Re: Comprehensive Permit for Preliminary Plan Review – Village at Tiogue located at Tiogue Ave., and Tiffany Rd., Assessor’s Plat 32, Lots 149, 150, 151, and 153 (“Property”)

As you know, this office represents 232 Realty Associates, LLC in its Comprehensive Permit Application for the development known as the Village at Tiogue (“Project”). This correspondence is in response to the November 13, 2025 staff report, the November 10, 2025, TRC report, and feedback from the November Planning Commission meeting on this Project. The public comments did not finish at the November hearing, and the applicant intends to respond to all relevant public comments, besides comments already addressed in this correspondence and prior submissions, after the first round of public comments is completed in December and in advance of the next hearing on this Project by the Planning Commission.

Area 1

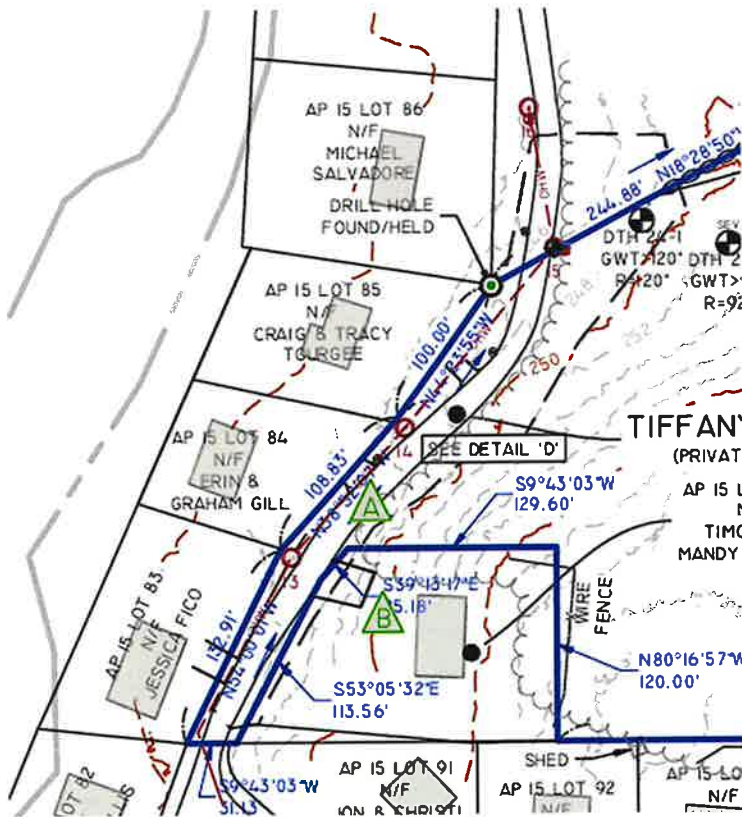
All roadways are designed with 12’ travel lanes and 1’ of berm resulting in a total of 26’ wide paved roadway.

Area 1 proposes a private roadway off of Tiogue Avenue, ending in a cul de sac, with bituminous berms on each side and no sidewalks. As private roadways, no specific adjustments are needed, since the Land Development and Subdivision Regulations do not provide detail or requirements for private roadways.
